REPORT FOR ACTION

Demolition of Three Heritage Properties in the South Rosedale Heritage Conservation District - 5, 7, and 9 Dale Avenue - Supplementary Report

Date: July 25, 2018
To: City Council
From: Chief Planner and Executive Director, City Planning
Wards: Ward 27 – Toronto Centre-Rosedale

Attachment 3: Revised Proposal - Site Plan

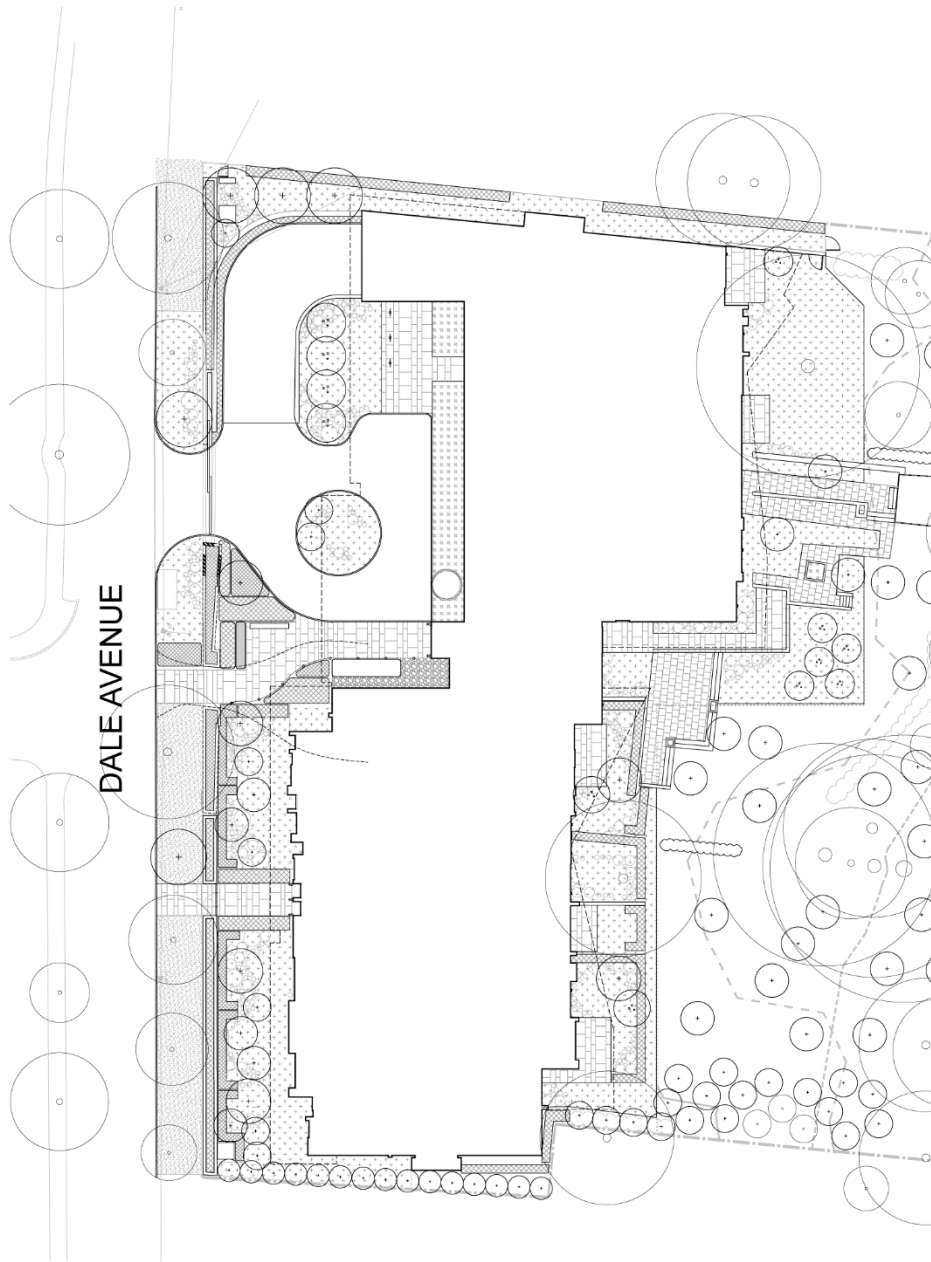
In this instance, HPS Planning staff found that the original proposal did not sufficiently conserve the heritage attributes found in Section 4.2.2 "Streetscape Heritage Character" of the Study and was therefore neither equally or more able to contribute to the heritage character of the district. For example, the replacement building would have significant visual impact on the landscape setting when viewed from the street and it would negatively affect the HCD's park-like setting.

- Retaining the "tea house", planting beds and garden walls, and as much of the historic landscape and landscaping features as possible in the rear yard of 7 Dale Avenue to be used as a common outdoor amenity space, subject to the approval of TRCA and RNFP staff. Planning staff have begun discussions with the TRCA regarding these modifications;
- Retaining as much of the historic landscape and landscaping features at the front of the property as possible, such as the front yard boundary wall-planter, iron railings and gates;
- Extending the front yard planters in a form that does not replicate but responds sympathetically to the existing planters;
- Removing front yard outdoor patios and two pedestrian walkways to increase the amount of soft yard landscaping;

- Landscaping the new front and rear yards in a form that is sympathetic to the design principles of the existing landscaping;
- Reusing existing paving materials for the front entrance walkway, the emergency walkway from the west half of the building, and rear terraces;

The with prejudice settlement offer responds to the concerns raised by conserving elements of the heritage landscape and modifying the building to increase the amount of soft landscaping on the site and views through the two wings of the building.

Attachment 4: Revised Proposal - North Elevation

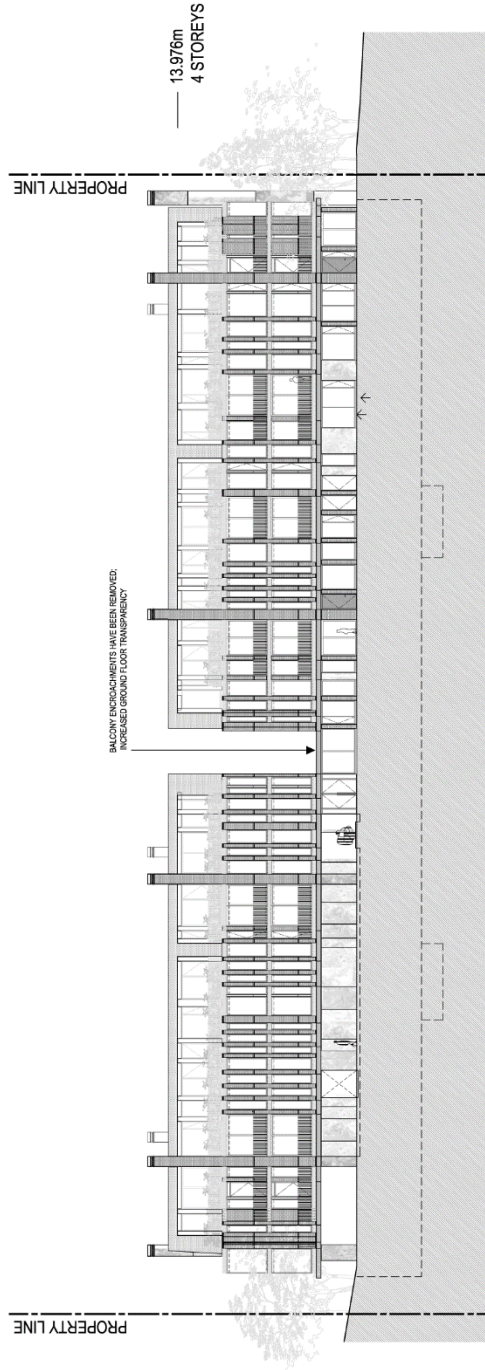
- Continuing the west side yard beech trees into the front yard to further screen the building from the public realm;
- Removing balcony encroachments into the 3.6-metre gap between the two halves of the building to increase visual permeability into the ravine; and

- Decreasing the depth of the 1-storey portion of the building connecting the two halves of the building and making the north and south walls fully transparent to further enhance the visual permeability into the ravine.

Attachment 5: Revised Proposal - West Elevation

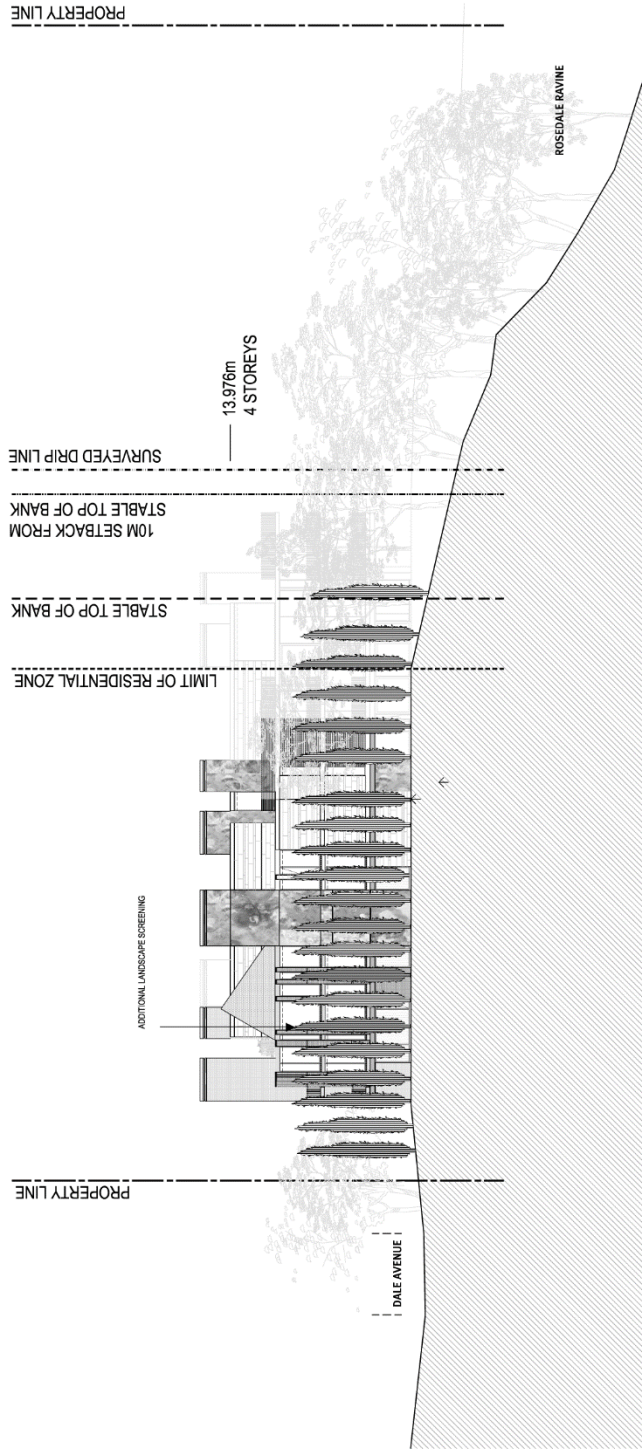
- Increasing the west side yard setback for the front portion of the building to a minimum of 2.5 metres to allow sufficient space for 6 inch caliper, 25 foot tall beech trees to be planted along the west side wall;
